TUSCARORA LAKE DAM

(NDI I.D. PA-0049
DER I.D. 058-027)

~~OWNER: JAYNE'S ORCHARDS~~
Susquehanna River Basin, Tuscarora
Creek, Susquehanna County, Pennsylvania.
PHASE I INSPECTION REPORT

PHASE I REPORT
NATIONAL DAM INSPECTION PROGRAM
TUSCARORA LAKE DAM
NDI I.D. PA-0049
DER I.D. 058-027

PLATE 2

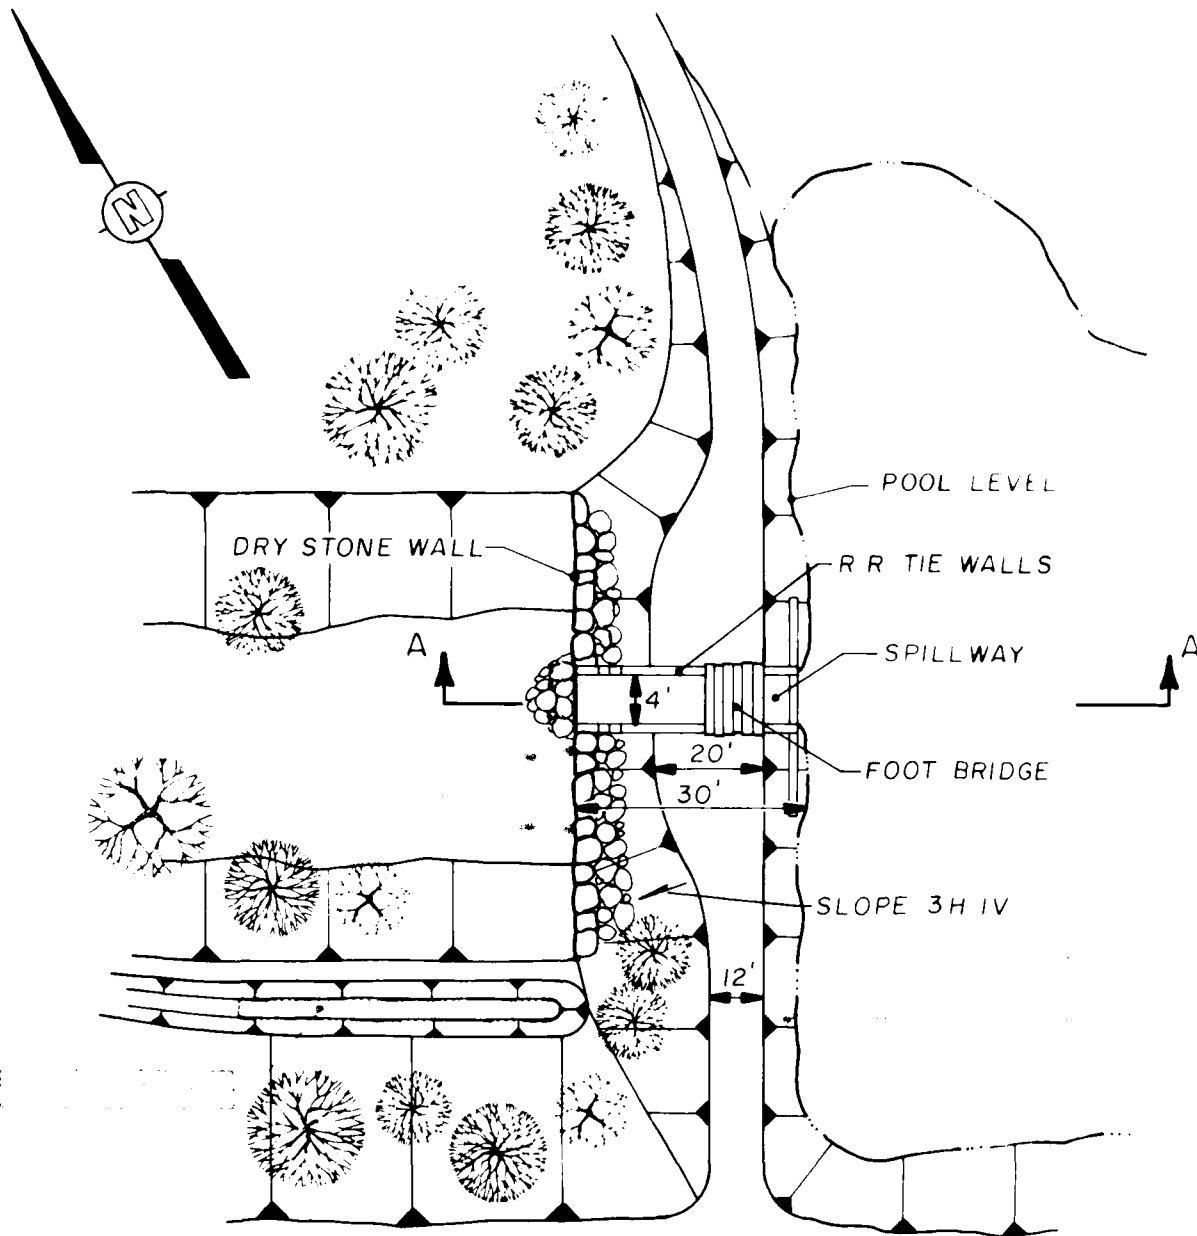
The specific observations are illustrated in Plate 2.

In general, the condition of the embankment is considered to be fair. Two seepage points were found along the toe of the downstream stone wall. Total discharge from the seepages was estimated to be about 10 to 20 gallons per minute. Other than this seepage condition, no additional signs of distress were noted. The upstream shoreline was irregular and lacked erosion protection; however, no significant shoreline erosion was observed.

c. Appurtenant Structures. The spillway channel is constructed of railroad ties forming walls above a concrete slab. Concern exists due to both the size and the manner of construction of the spillway. Because of the small size of the spillway channel, about 4 feet wide and 2.5 feet deep, it is considered vulnerable to blockage by debris during storms, which could result in overtopping of the embankment. It appears that the railroad tie walls could be washed out during storms, initiating a breach through the dam.

3.2 Evaluation. The overall condition of the embankment is considered to be fair. Installation of a structurally and hydraulically adequate spillway is required. In conjunction with this work, means should be developed to draw down the lake, and the need for providing erosion protection along the upstream face should be evaluated.

PLATE 3

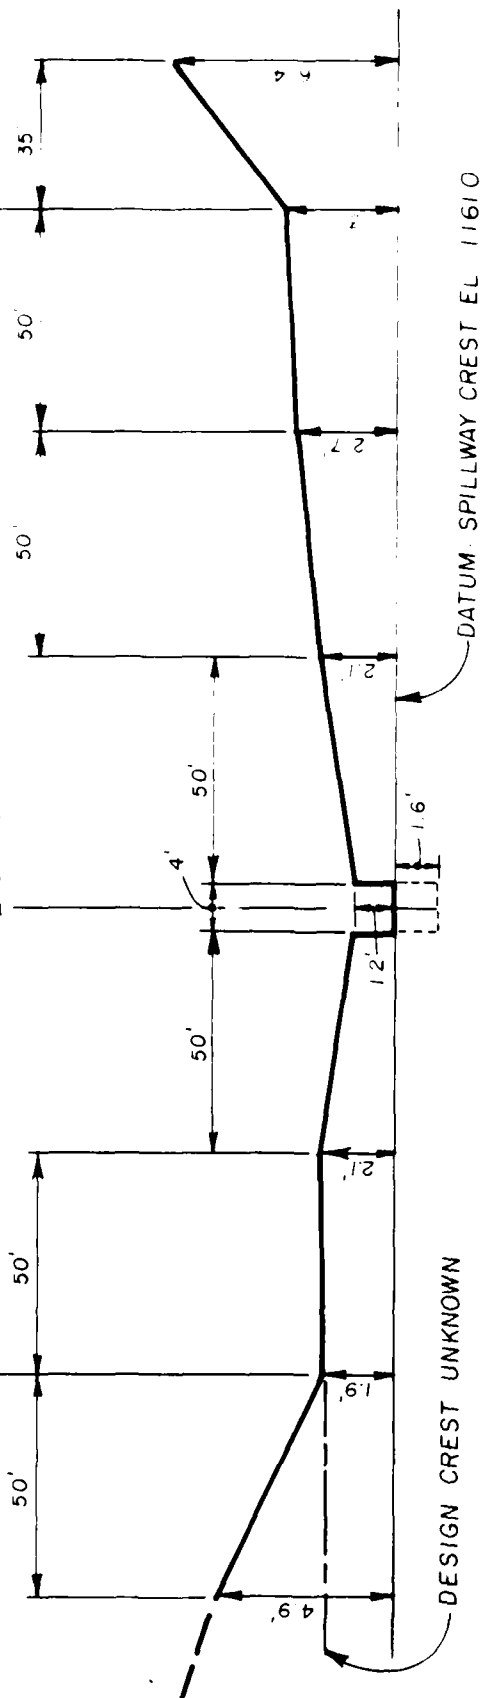
The crest of the dam was surveyed relative to the spillway crest elevation, and the crest profile is illustrated in Plate 3. A 30- to 50-foot section of the embankment on each side of the spillway was found to be lower than the remaining portions of the dam.
